Groundwater Application Review Summary Form

Application # G- <u>18888</u>
GW Reviewer <u>Aurora C Bouchier</u> Date Review Completed: <u>May 13, 2020</u>
Summary of GW Availability and Injury Review:
Groundwater for the proposed use is either over appropriated, will not likely be available in the amounts requested without injury to prior water rights, OR will not likely be available within the capacity of the groundwater resource per Section B of the attached review form.
Summary of Potential for Substantial Interference Review:
\square There is the potential for substantial interference per Section C of the attached review form.
Summary of Well Construction Assessment:
☐ The well does not appear to meet current well construction standards per Section D of the attached review form. Route through Well Construction and Compliance Section.
This is only a summary. Documentation is attached and should be read thoroughly to understand the basis for determinations and for conditions that may be necessary for a permit (if one is issued).

Application G-18888 Date: May 13, 2020

Geologic Map

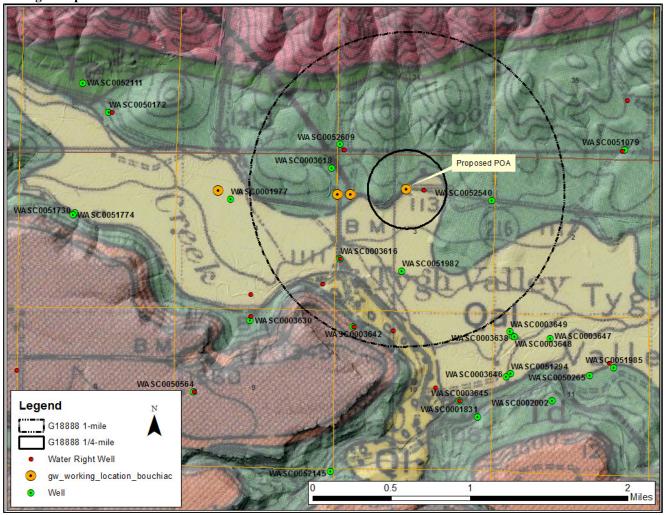
Basis for aquifer confinement evaluation: *Based on the location it appears that the well will be constructed into interbedded sandstones/claystones and lava flows of the Dalles Formation. The nearby well logs list the SWL above the first water-bearing zone, but not by a large amount. It may be more accurate to describe the aquifer as semiconfined.

Water-Level Trends in Nearby Wells

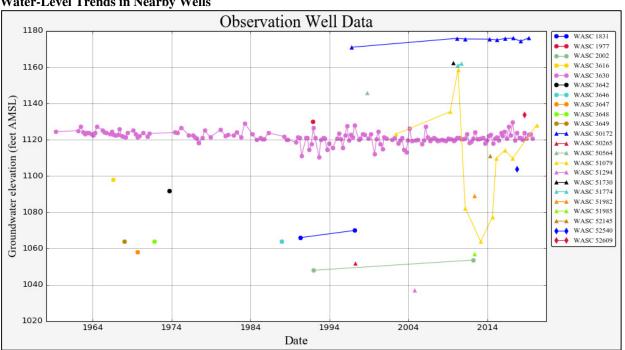
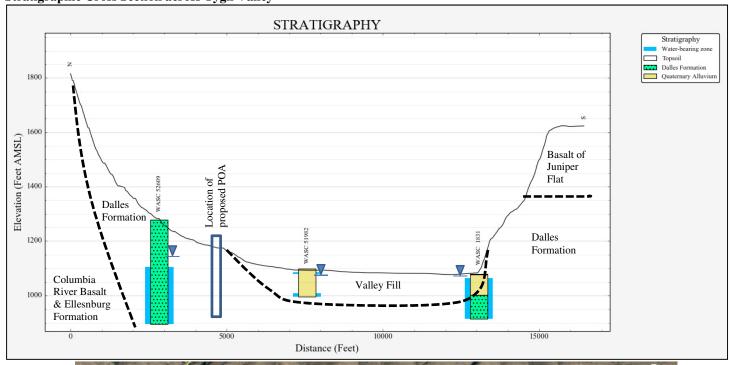
Groundwater availability remarks: There are a number of nearby wells completed in the Dalles Formation. WASC 3630 (located on the south edge of Tygh Valley) has been monitored since the 1960's and shows no decline and a water-level coincident with nearby reaches of Tygh Creek. Two nearby wells (WASC 51079, located approximately 2 miles to the west along the north flank of Tygh Valley and WASC 51079 located approximately 1-1/2 miles on the hillsides to the northeast) have water-level permit conditions. Water-level measurements from WASC 51079 are relatively erratic, likely a response to pumping and restricted to a small locality. Aside from WASC 51079, the hydrograph for nearby wells indicates overall stable conditions at the current use. The estimated yield listed on the nearby well logs range from 20 to 500 gpm. It appears likely that a well completed in the	d.	to occur with this use and without reconstructing are cited below. Without reconstruction, I recommend withholding issuance of the permit until evidence of well reconstruction is filed with the Department and approved by the
